**The Thanet Extension Offshore Wind Farm - Material Change Consultation  
Response by the Port of London Authority and Estuary Services Limited**

**Response to the Applicant's Consultation on a Material Change to the Application submitted on behalf of the Port of London Authority and Estuary Services Limited**

Unique Reference Number	EN010084
Document Ref.	PLA 21 / ESL 21
Author	Winckworth Sherwood LLP
Date	24 May 2019

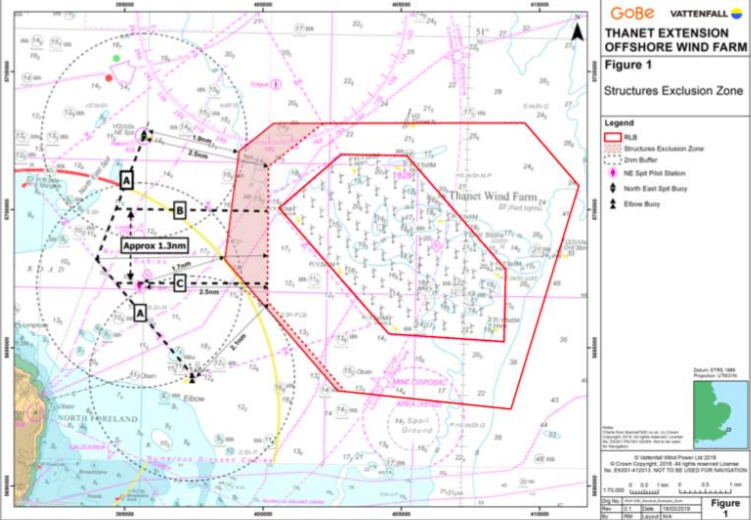
Consultation document	Document reference	Response summary/extract	PLA/ESL comments
<p>Document 1</p> <p>Appendix 14 to the Deadline 4 Submission – Structures Exclusion Zone Explanatory Report</p>	<p>Section 3.3</p>	<p>‘Sea Room’ and ‘Buffers’</p>	<p>The PLA and ESL agree with the position of the Applicant that sea room should be a calculation of operational area (be it on passage or pilot transfer) together with a buffer.</p>
	<p>Section 3.4, paras 21-23</p>	<p>Vessel assumptions</p>	<p>Figure 38 in the NRA (Section 5.6 <i>Seasonality</i>) summarises the daily transit rate through Traffic Gate E, which summarises a daily transit rate of between 32 (winter) and 45 (summer) transits per day (based on the results of the traffic survey). The Applicant has stated in their response to ISH8 action point 12 (Appendix 7 to deadline 5/para 88) that Gate E is used to analyse vessels per day on the inshore route. Gate E is not assessed in the NRAA per se; the transit analysis in the NRAA covers the area between Elbow Buoy to SEZ and NE Spit Buoy to SEZ. It would appear that the overall traffic per day figure for the entire inshore route is derived from these two positions. The PLA and ESL do not think this is an accurate reflection of vessels per day on the inshore route, as carrying out an analysis from these two positions alone would not in their experience be representative of the traffic in the area as a whole.</p> <p>The Applicant suggests that they think it is unlikely that the frequency of larger vessels using the inshore route will increase given historical evidence. However in the NRAA (para 121) they acknowledge a trend toward vessel size increasing. The PLA and ESL not consider it a a fair assumption, based on historical use,</p>

Consultation document	Document reference	Response summary/extract	PLA/ESL comments
			<p>that the growing number of larger vessels will still only use the inshore route with the same frequency.</p> <p>The PLA and ESL would agree that factors such as a reduction in sea room on the inshore route, as a result of the extended wind farm, could create a restriction when assessing the routes suitability for larger vessels.</p>
	Section 4.3	Sea room requirements for vessels on passage	<p>The Applicant concludes, based on the MSP guidance, that it has adopted a highly precautionary approach by allowing for four 333m vessels. However, the PLA and ESL consider that a fuller adoption of the MSP guidance would be necessary in order for the approach to be a precautionary approach.</p> <p>The Applicant should included the recommended distance for a safe turn to starboard in accordance with the COLREGs; it did not. If it had, that would give a 'baseline' distance/sea room for passage of 2.72nm on the inshore route (as demonstrated in the PLA and ESL's deadline 4c submission/EN10084/2.1.3 and 2.1.4). It would then be precautionary to attempt to 'factor in' other navigational, and therefore sea room, requirements, such as the fact that the route has within it a high volume of crossing traffic, a pilot station, the North East Spit bank and the existing TOW itself, as well as an anchorage to the west.</p>
